AL126 Series

High Dispersion Narrow Bar Lights

Change Notice

PCN No: 144

Washdown Lights Flowable Silicon

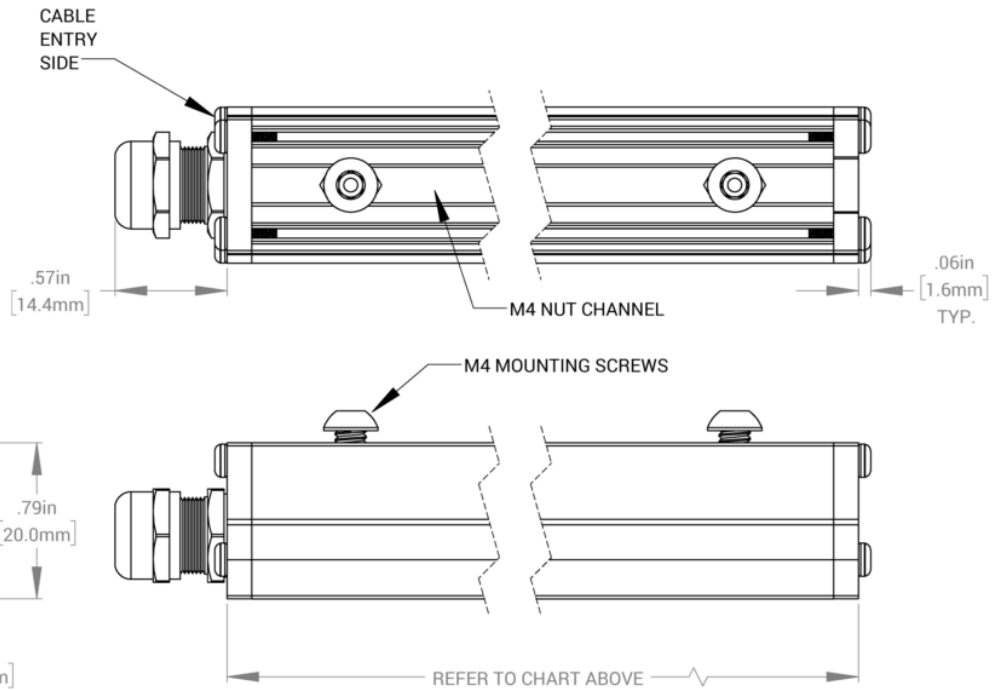
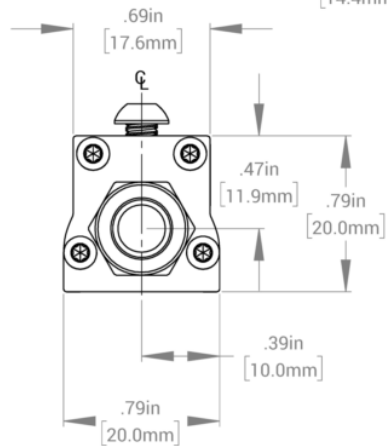
Advanced illumination (Ai) is improving the way we manufacture washdown lights which will change their outward appearance. We will be replacing the black cordstock with clear flowable silicon. This change will provide a more durable finish and will effect the following lights: AL116, AL126, AL143, AL179, AL295, BL128, QM116, QM126, LL174 and SL147.
